**Request for Tender for
INSTALLATION OF ELECTRIC VEHICLE CHARGING STATIONS****TZC T 04-2020-02****ADDENDUM 2**

Request for Tender
TZC T 04-2020-01 Installation of Electric Vehicle Charging Stations
Part 3 – Scope – Addendum #2

TZC T 04-2020-01 – INSTALLATION OF ELECTRIC VEHICLE CHARGING STATIONS

DRAWING #:
A0.00

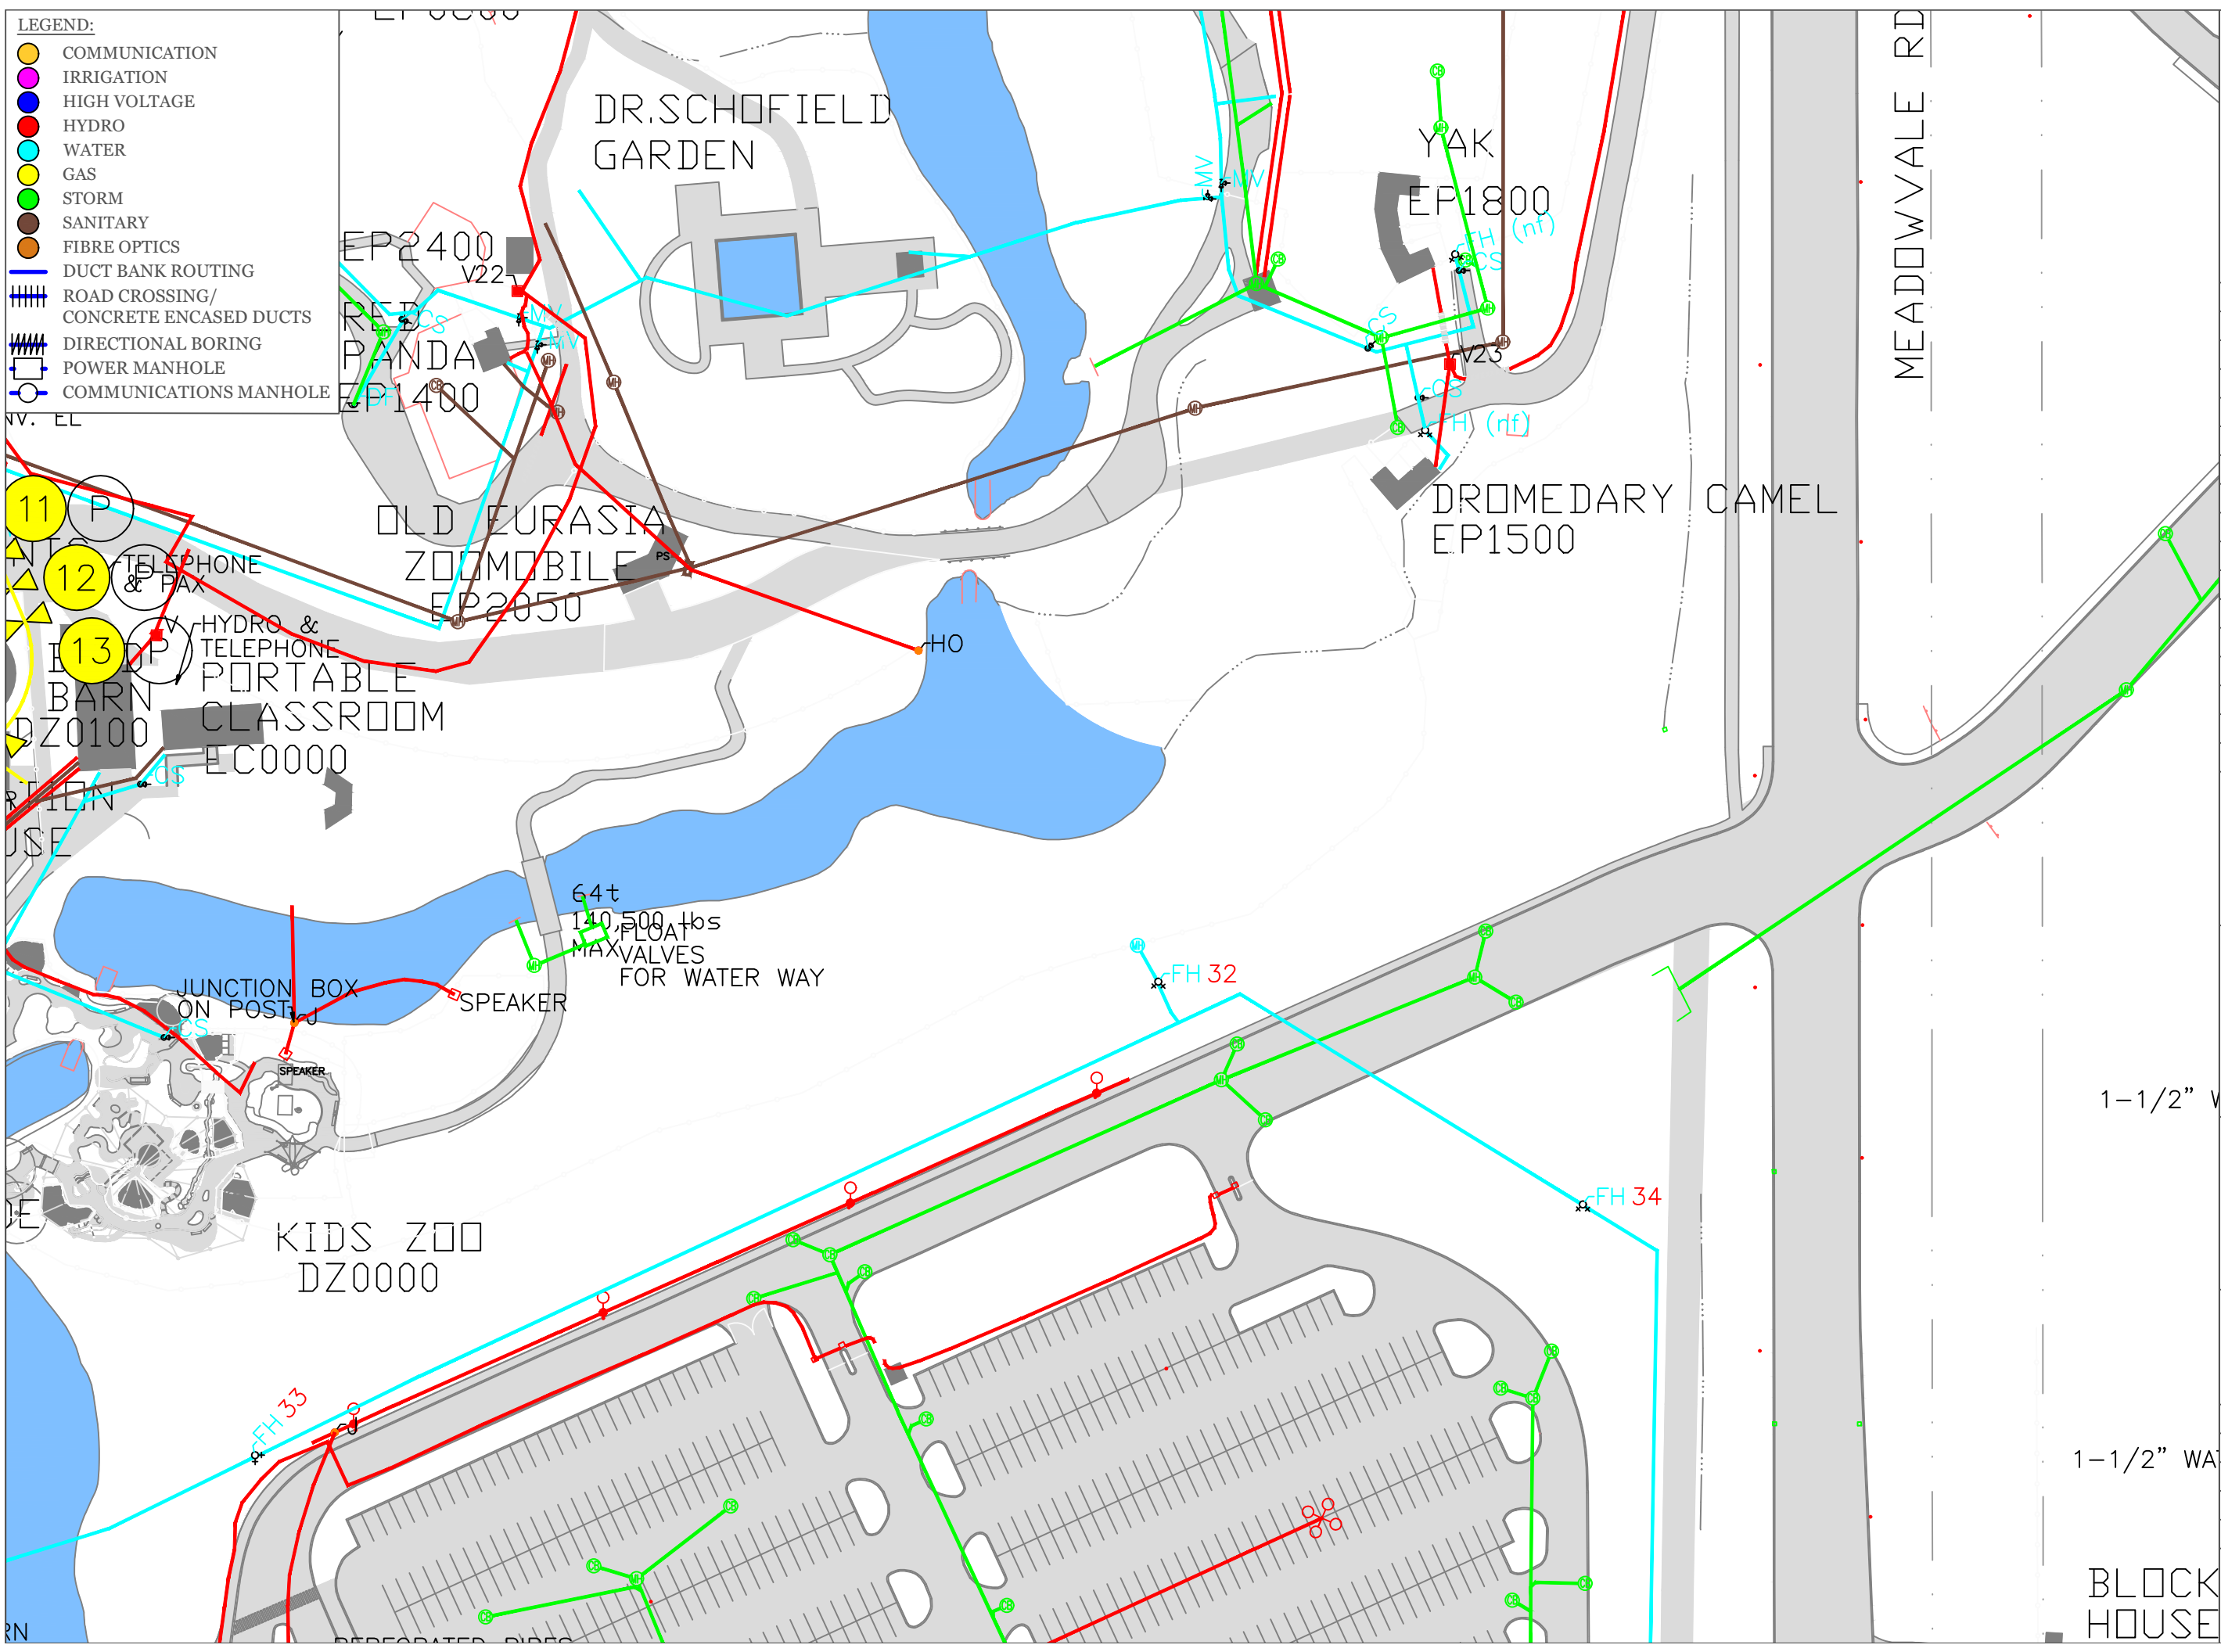
Has the Toronto Zoo scanned the hill north of the charging locations to show where the existing water service & fire hydrant pipes are exactly located?

At the site meeting Ben advised a site services plan was to be included in an addendum? Please provide.

The Toronto Zoo will complete locates for the project before work begins. Please see the attached A0.00 - Site Services Plan.

Please see the attached A0.00 - Site Services Plan.

SK-02 REV1
CHARGER LOCATIONS

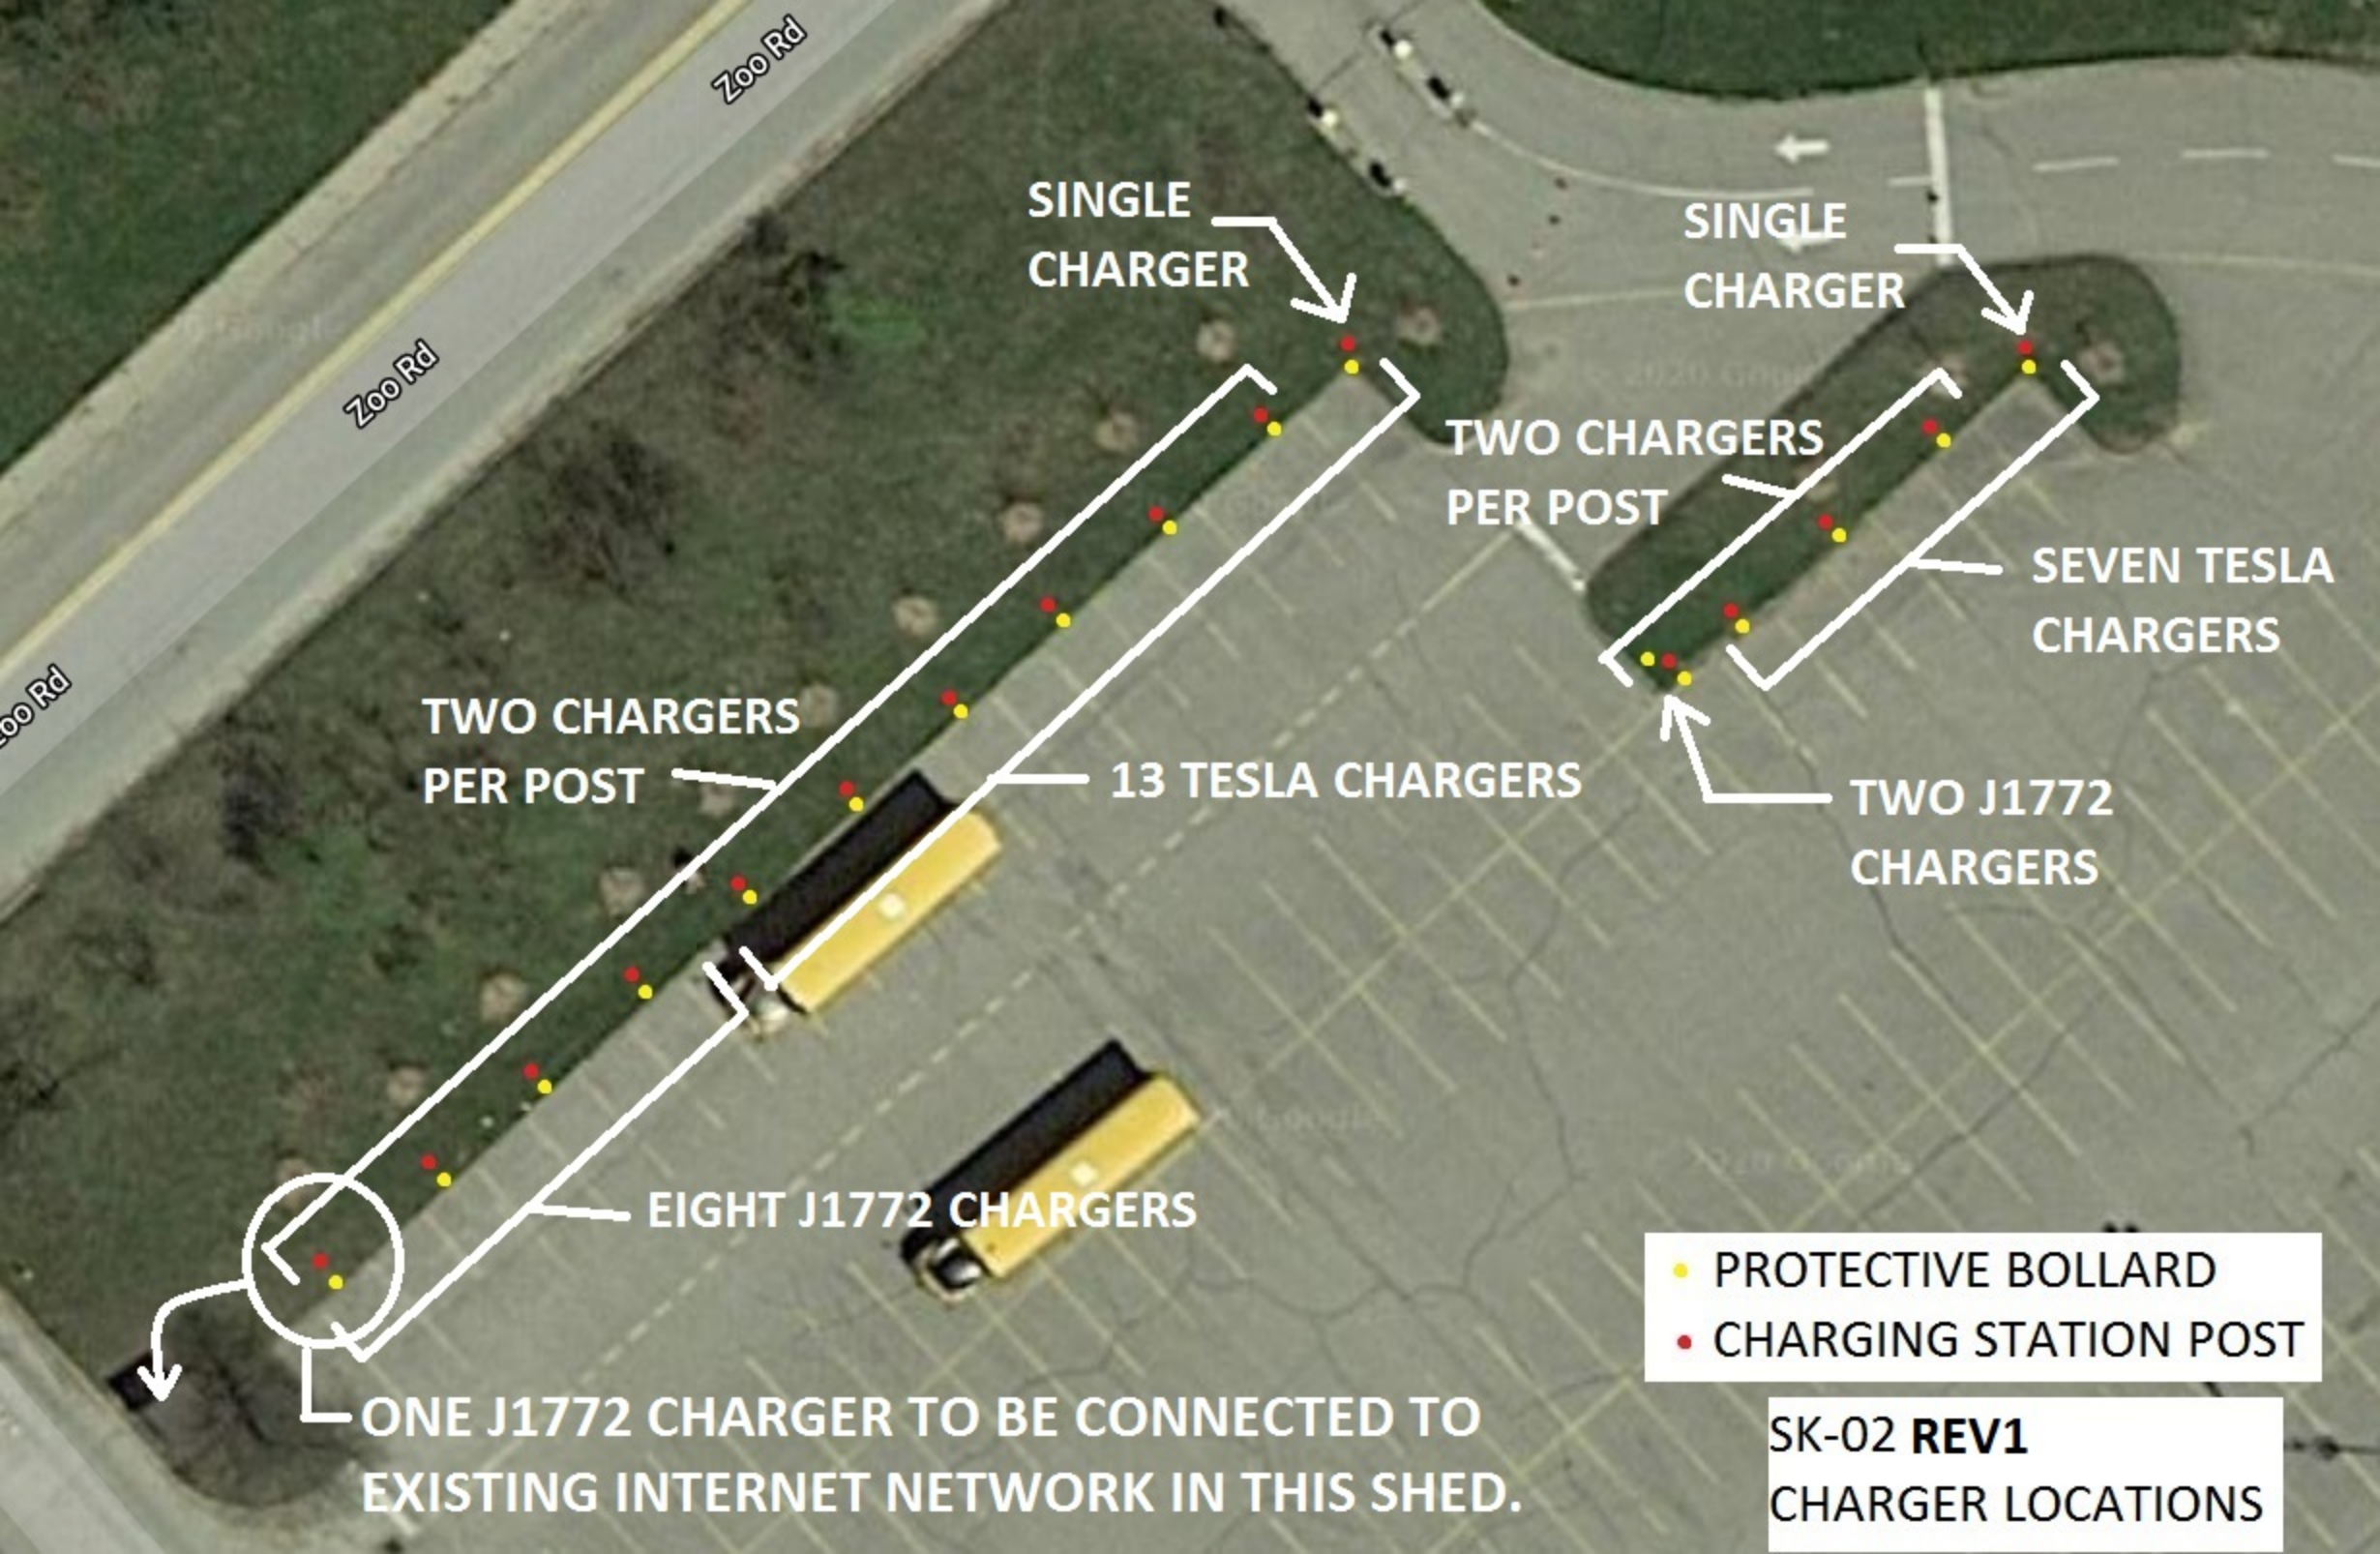
Clarification that contractor is responsible to extend from shed building communication cable.

See revised Part 3 – Scope, Item 1.2.7.3 and revised SK-02 REV1.

ONE J1772 CHARGER TO BE CONNECTED TO EXISTING INTERNET NETWORK IN THIS SHED.
